OSART

CRUAS

NUCLEAR POWER PLANT

**DIVISION OF NUCLEAR INSTALLATION SAFETY
OPERATIONAL SAFETY REVIEW MISSION
IAEA-NSNI/OSART/08/148F**

The diagram below (based on assessments by corporate level) shows the trend in the NPP's condition:

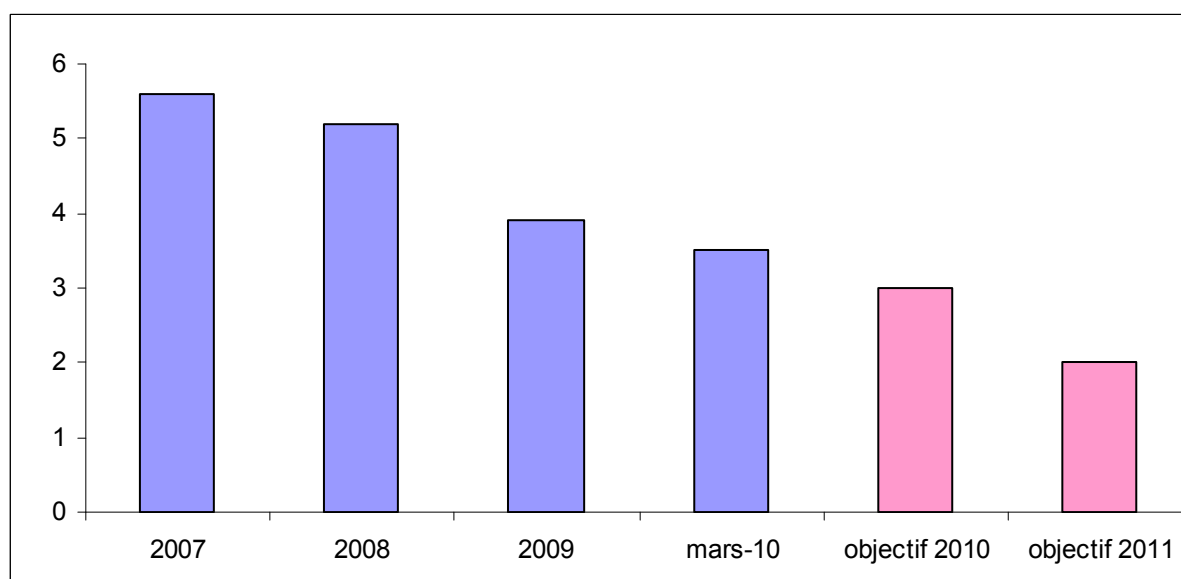
The plant has a programme on reaching exemplary plant conditions (OEEI) which has been in progress for two years. Several signs on improving material conditions such as elimination of leaks and initiation of observation sheets (FIDO) to identify minor deficiencies are obvious. However, there is a large backlog in the work control system (SYGMA) and FIDO databases. Moreover, the following deficiencies have not been solved.

The plant should perform remedial measures to mitigate degradation of structures, systems and components to ensure good equipment condition.

For plant condition, the plant has strengthened its “reaching exemplary plant conditions” project in order to ensure that standards are met and that actions undertaken will be long-lasting.

Over a period of 4 years, more than €33m will have been spent, to renovate civil engineering and equipment, buy materials to protect floors and collect leaks, improve lighting, labelling and cleaning and make modifications on equipment with recurrent leaks. Investment will continue in 2011.

To measure the effectiveness of its action plans, the plant is regularly assessed by experts from EDF corporate departments.

On this scale, level 2 corresponds to “Good”, level 3 to “satisfactory”, level 4 to “average”, level 5 to “acceptable” and level 6 to “unsatisfactory”.
